T.I. no.: 2017 - 03 Updated: -	Topic: Twin Topping partition wall and filling aid
---	---

Date: 27/2/2017
Affected machines: SCV
From serial number: -
As of date: 1/3/2017

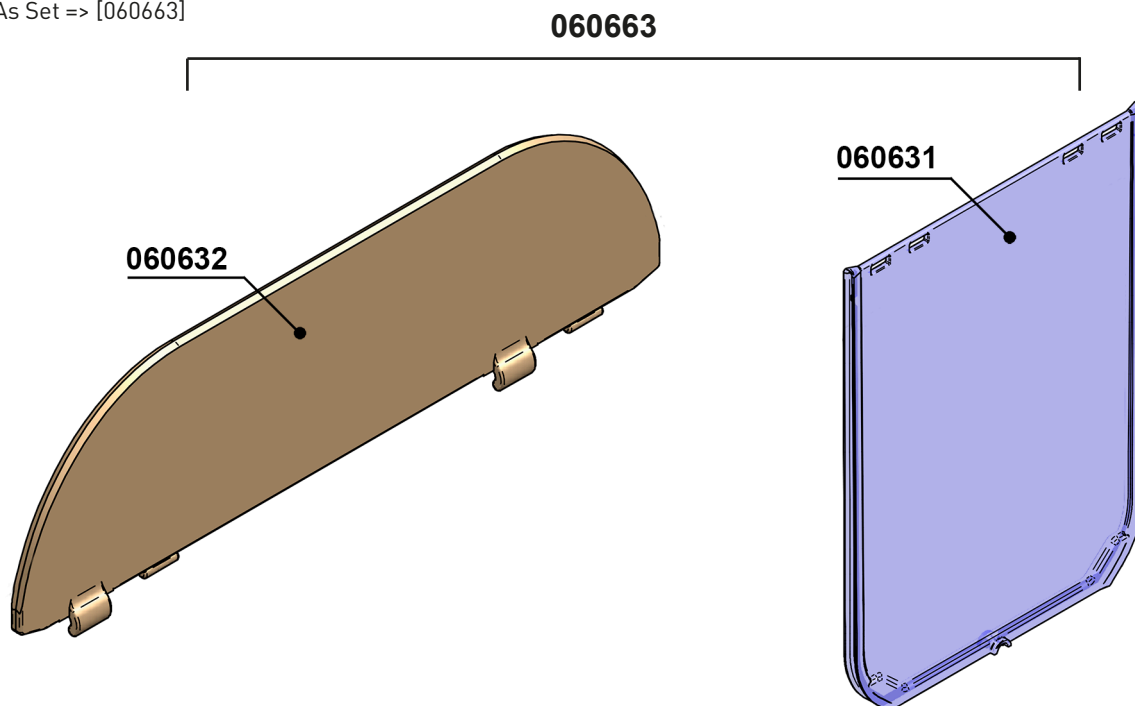
Part "060632 Twin Topping filling aid" and part "060631 Twin Topping partition wall" have been modified.
The retaining cam on the filling aid has been reinforced. Installation of the partition wall with filling aid is now easier.

Both parts are available individually, but please note that the parts are not backwards compatible.

Both parts are available in the modified version as a set with part number 060663.
